## Technical Note

| Our Ref    | 22042-TN-1-R0                  |

## Phase 2 & 3, Newton Heath Planning Noise Addendum

This technical note provides a response to noise comments raised by Manchester City Council (MCC) in relation to the above proposed development and the submitted Noise Impact Assessment Report 22042-RP-1-R1.

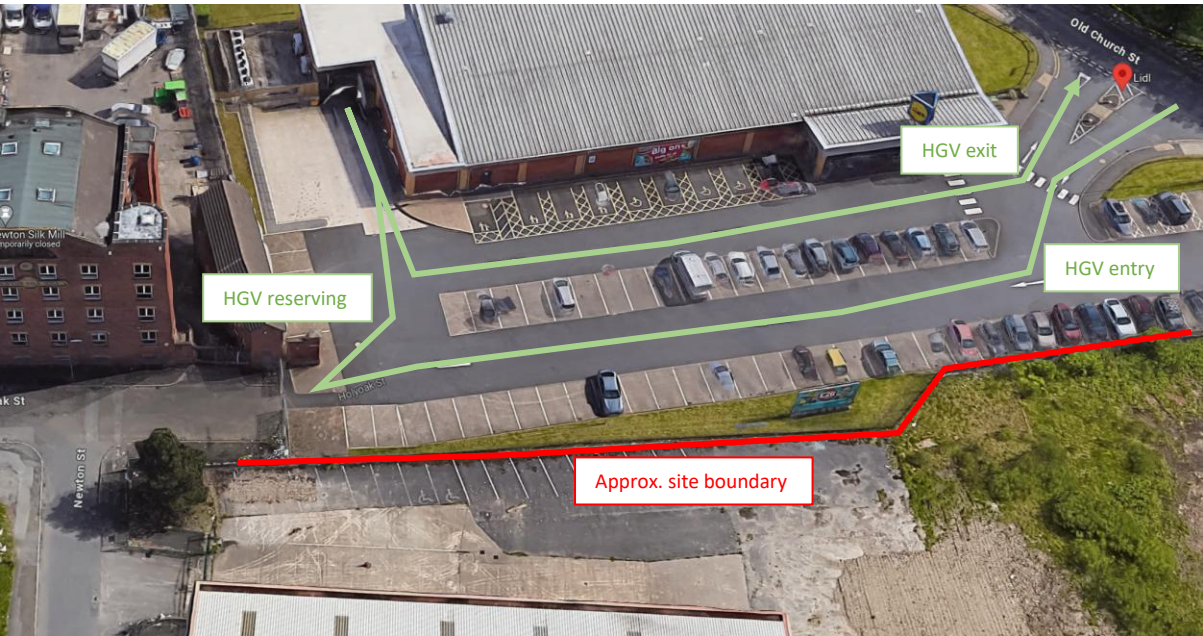
*EH are in receipt of a noise assessment report by Jameson dated Aug 23. More information is needed regarding the delivery hours, number of vehicles and route of the HGVs for Lidl to ensure that the noise of this does not impact the proposed residential. If there is no impact: EH accept the glazing specification stated in 7.2.2.*

Jameson Acoustics has previously undertaken noise level measurements of supermarket delivery activities at numerous sites. Measurements capture noise levels from HGVs entering the site and manoeuvring into position, unloading activities (involving wheeled cages of products transferred to/from lorries directly into the loading bay port) and HGVs exiting the site. These are summarised below, with results normalised to a reference distance of 5 metres. Note, the  $L_{Aeq}$  noise levels have been converted into single event ‘sound exposure levels’ (SEL) by normalising the single event  $L_{Aeq}$  level to one-second.

We understand the deliveries to Lidl could occur anytime during the day/night, but are often in the early morning hours. We shall assume this to be between the hour of 04:00-05:00 hr for a worst-case assessment, when the prevailing noise climate is low (lowest recorded noise level of 47 dB  $L_{Aeq,15min}$  at survey Position 2 in our Report).

Deliveries occur to the east of the Lidl store, as indicated below. There is a loading bay port (with rubber flaps to the opening perimeter) within the building façade, so that deliveries vehicles can reverse and load/unload directly into an internal service area. See below Photograph.

Overheating acoustic zones:

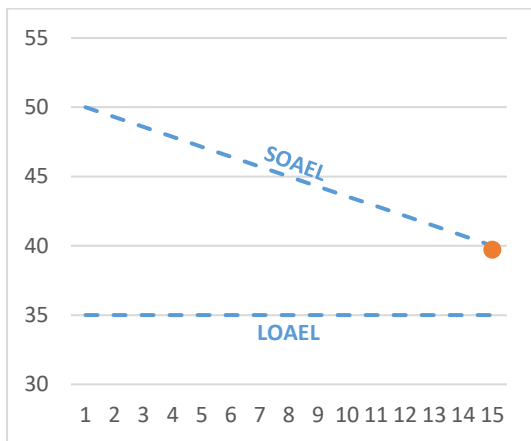
*Re overheating in 7.3, EH agree with MVHR with a boost function in the black and purple zones. Other mitigation methods discussed should be looked at in conjunction with MVHR. For the other zones, please include the AVO assessment to further justify MEV.*

With reference to our report, the overheating acoustic zones were split into three; black, purple and green. For the black and purple zones, the overheating strategy shall assume windows are closed at night (in line with Part O) and MVHR with boost functions provided to reduce reliance on openable windows during the day.

For the green zone, daytime and night-time noise levels are sufficiently low enough to permit openable windows. For night-time, Part O requirements supersede the AVO and, in line with the IOA's 'Guide for Demonstrating Compliance with the Noise Requirements of Part O' the threshold for acceptance can be taken

as 49 dB  $L_{Aeq,8hr}$  and 64 dB  $L_{Amax}$  (upper limits). The calculations and noise modelling results presented in our report demonstrate noise levels at night will fall below these upper limits for the green zone dwellings.
